RE: Mid-City Communities Plan Update

APPENDIX A

SB79 Affected Parcels

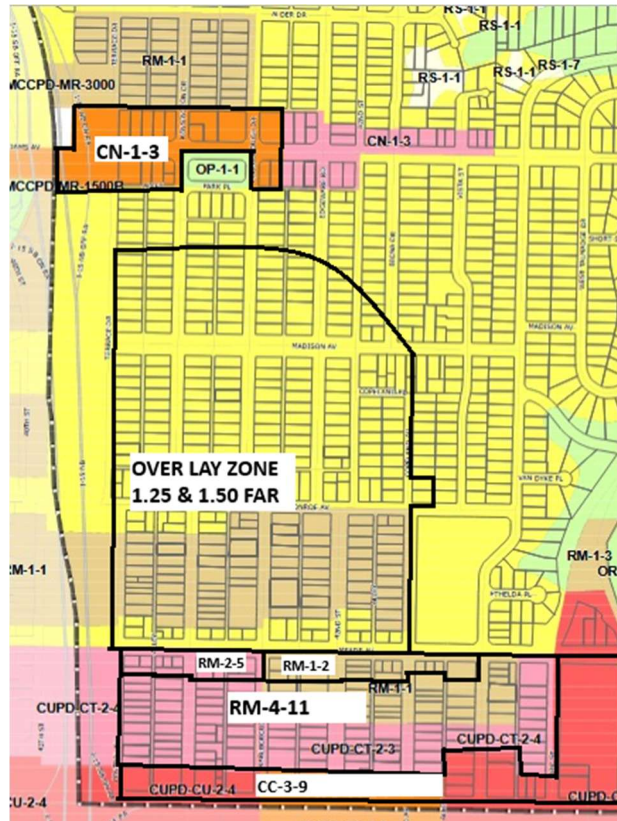
The blue and purple represent the inner ring up to ¼ mile from the transit station, where SB79 mandates a FAR of 3.0, and the two shades of green are the outer ring areas, ¼ mile to ½ mile from the designated major transit stop, where a FAR of 2.5 is mandated. The map excludes the very high fire hazard severity zones as allowed under the terms of SB79.

CC-3-9 zoning is proposed for properties facing El Cajon Boulevard which are currently zoned CU-2-4, a zone currently available under the Central Urbanized PDO which is planned for repeal.

KENSINGTON MAP

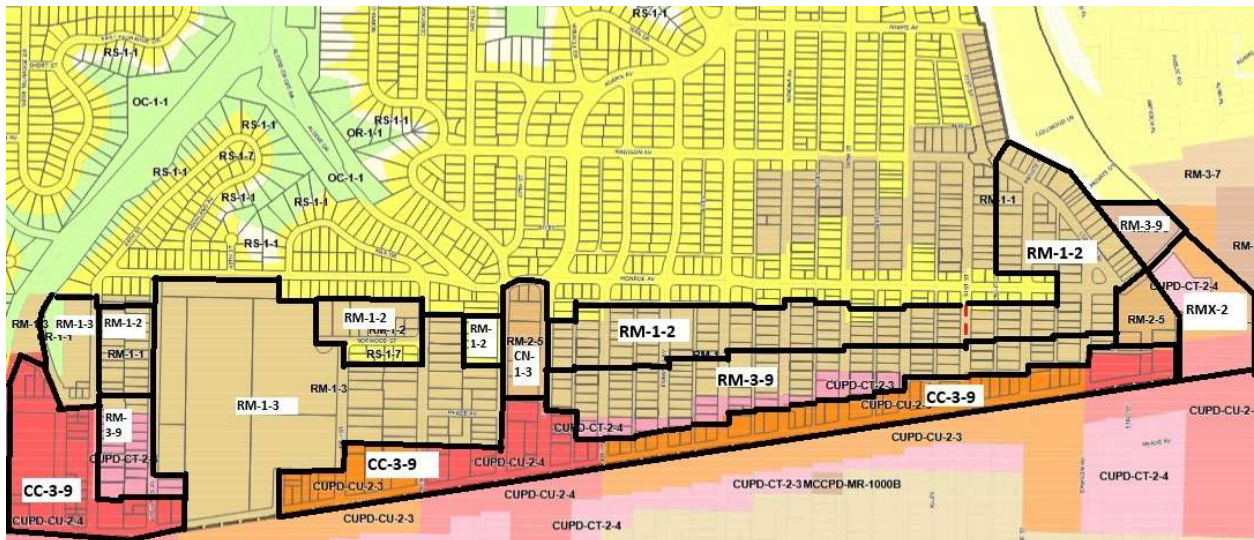
Since CC-3-9 zoning was applied along El Cajon Boulevard to the west and east of this area during the North Park and College Area plan updates, respectively, it is our assumption that the City expects CC-3-9 zoning for this section of the boulevard as well. This CC-3-9 zoning will have to be accompanied by an overlay to account for SB79 as the CC-3-9 zones' specific FAR maximum is only 3.0 for mixed use. The overlay within the CC-3-9 zones should apply a 6.0 FAR in the purple and blue areas, and a 5.0 FAR in the green areas. If the City is developing a new CC zone above CC-3-11 to specifically fulfill the requirements of SB79 please let us know.

For the rest of the 4300 blocks north of El Cajon Boulevard, we propose a mix of RM-4-11, RM-2-5 and RM-1-2 zoning. The RM-4-11 zoning incorporates fully SB79-compliant zoning onto the map, and allows for slightly lower zoning along the south side of Meade Avenue. It also places the greatest density closest to the transit station.

Regarding the RM-1-2 zoning on Meade Avenue, we would like to specifically mention that it is strategically placed to minimize the shadowing effect of large buildings on the Franklin Elementary playing field which not only serves the children of that school, but represents 50% of the park points within the entire Kensington-Talmadge planning area. Shading, particularly during the winter would severely impact its use by the community in the afternoon hours, the afternoon being the only time it is available on weekdays to the general public.

North of Meade Avenue, the planning group proposes keeping the existing zoning within the SB79 affected areas, but applying a 1.25 and 1.5 FAR overlay to comply with SB79. On the SB79 map, we propose 1.25 FAR in the green and 1.5 FAR in the purple areas north Meade Avenue. We believe retaining the existing zoning would be more respectful of the pending Kensington Historic District which was first identified in the 1998 community plan.
